Access Compliance Report

Public Rights-of-Way

Intersection ID: 23101	Main Street: LYNBRIDGE_DR	Cross Street: PROVIDENCE_RD	Location: SW
ADA ID: 77FC62D9FC60	Ramp Type: Perp	Initial Pass/Fail: Fail	Overall Compliance: No
		Severity Score: 22.5

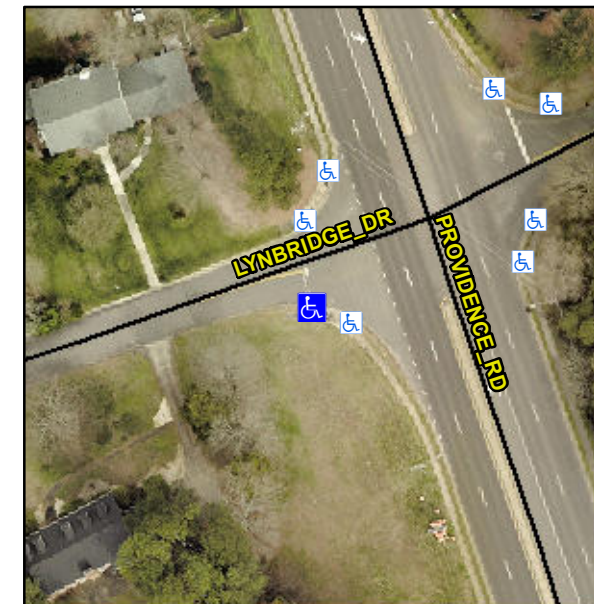
Not Found, R304.5.1, R304.2.2, R304.5.3

Compliance	Description	Data	Compliance	Description	Data
N/A	Ramp Length (in)	72.0	No	Ramp Slope (%)	9.1
No	Ramp Width (in)	44.0	No	Ramp XSlope (%)	2.9
N/A	Flare Type LT	N/A	N/A	Flare Type RT	N/A
N/A	Flare Slope LT (%)	N/A	N/A	Flare Slope RT (%)	N/A
N/A	Flare Traversable LT?	N/A	N/A	Flare Traversable RT?	N/A
N/A	Landing Length (in)	N/A	N/A	DWS Provided?	N/A
N/A	Landing Width (in)	N/A	N/A	DWS Contrast?	N/A
N/A	Landing Slope (%)	N/A	N/A	DWS Length (in)	N/A
N/A	Landing X Slope (%)	N/A	N/A	DWS Full Width?	N/A
N/A	Landing Curb? (Y/N)	N/A	N/A	DWS Offset (in)	N/A
N/A	Shared Landing?	N/A			
N/A	Gutter Ponding?	N/A	N/A	Gutter Slope (%)	N/A
N/A	Gutter Lip Ht (in)	N/A	N/A	Gutter X Slope (%)	N/A
N/A	Painted X Walk1?	No	N/A	Painted X Walk2?	N/A
	X Walk 1 Direction	To N		X Walk 2 Direction	N/A
N/A	X Walk 1 Width (in)	N/A	N/A	X Walk 2 Width (in)	N/A
	X Walk 1 Slope (%)	1.4		X Walk 2 Slope (%)	N/A
	X Walk 1 X Slope (%)	4.2		X Walk 2 X Slope (%)	N/A

Remove & Replace Entire Ramp.
